Contra Costa Clean Water Program

Hydrograph Modification Management Plan

May 15, 2005

Corrected April 19, 2006 (corrections listed on following page)

Figure 2. Cross-Section View of In-Ground Planter, Group C/D Soil Configuration

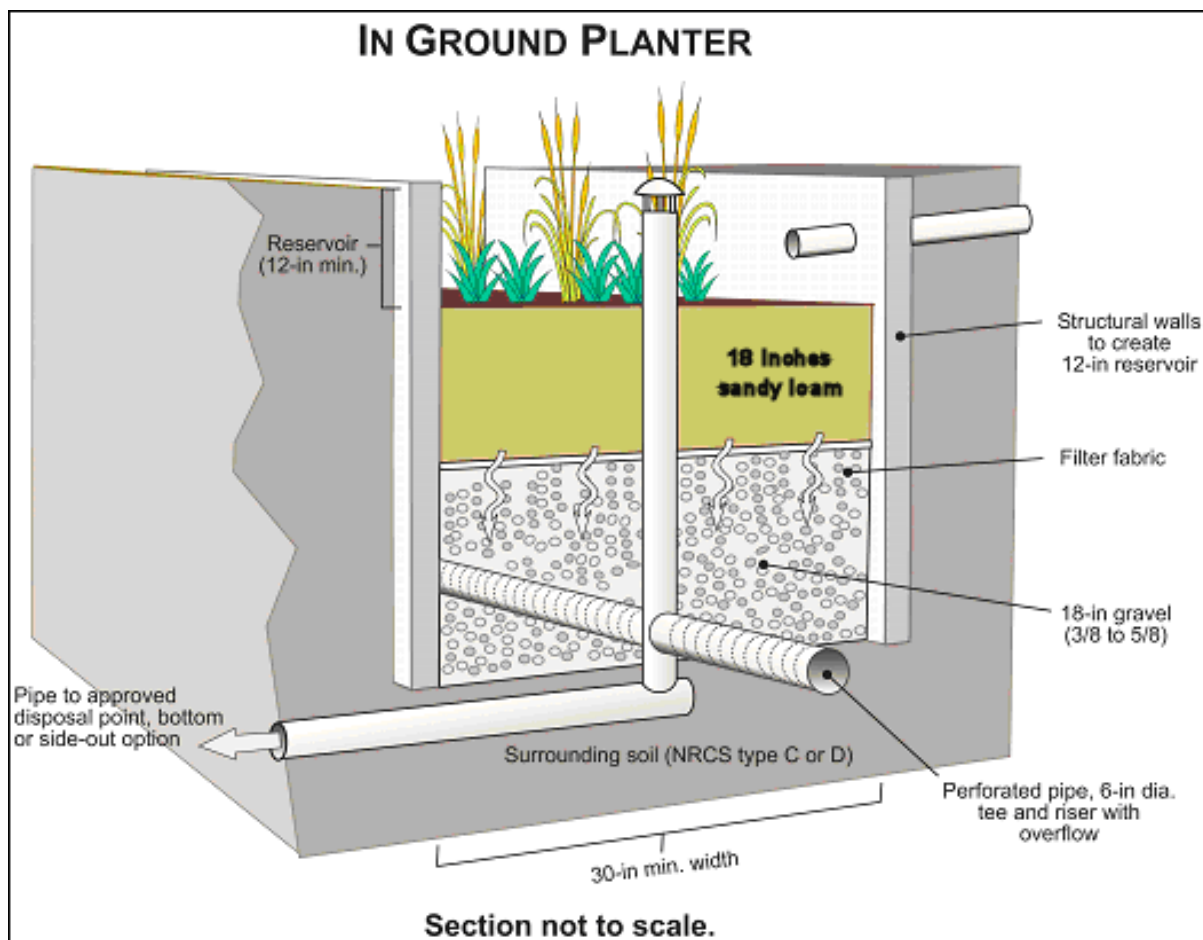
In Attachment 2, on page 14, label on Figure 2 has been corrected. The depth of 12 inches of sandy loam has been corrected to 18 inches, consistent with the text and the underlying modeling.

Figure 12. Cross-Section View of Flow-Through Planter, Group C/D Soil Configuration

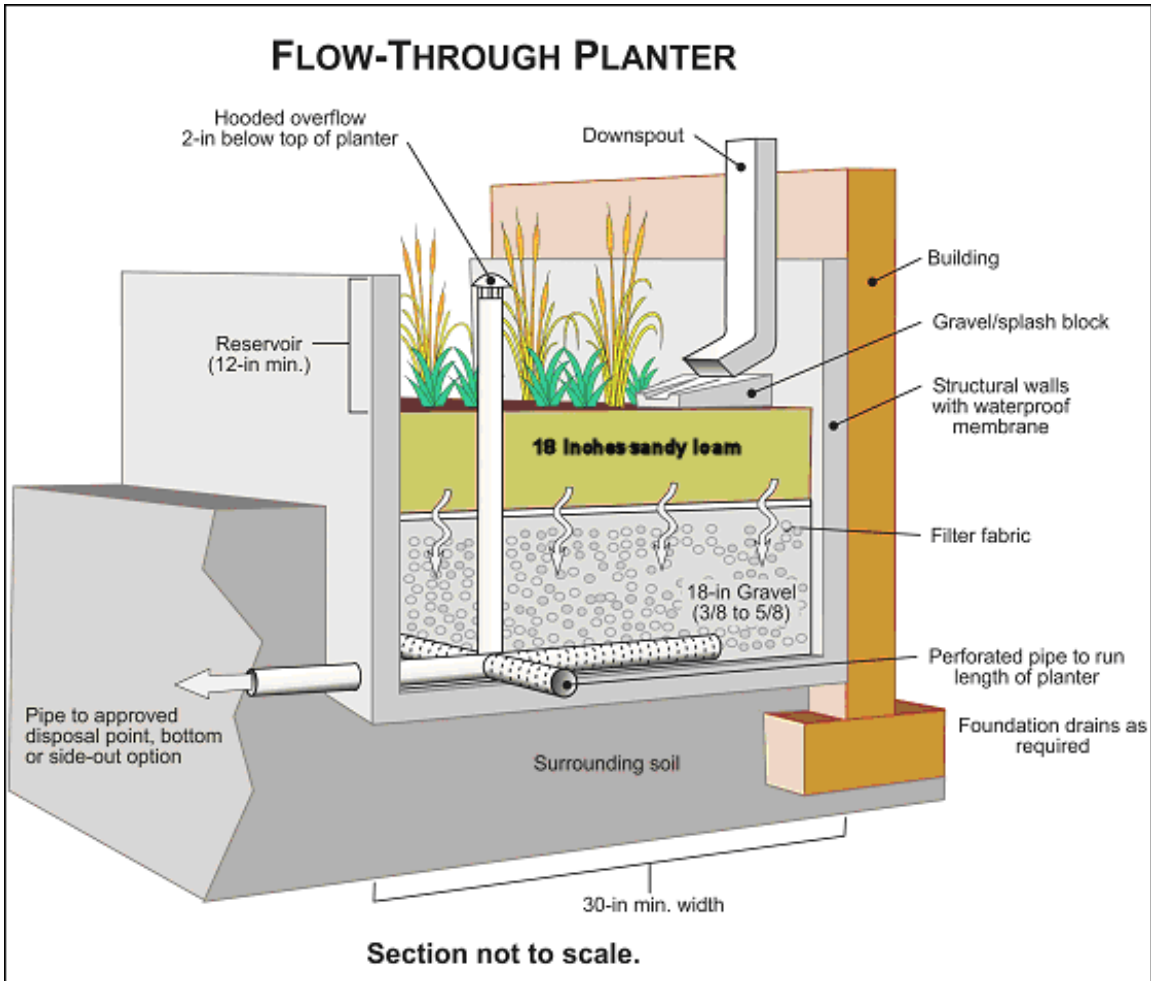
In Attachment 2, on page 29, a label on Figure 12 has been corrected. The depth of 12 inches of sandy loam has been corrected to 18 inches, consistent with the text and the underlying modeling.
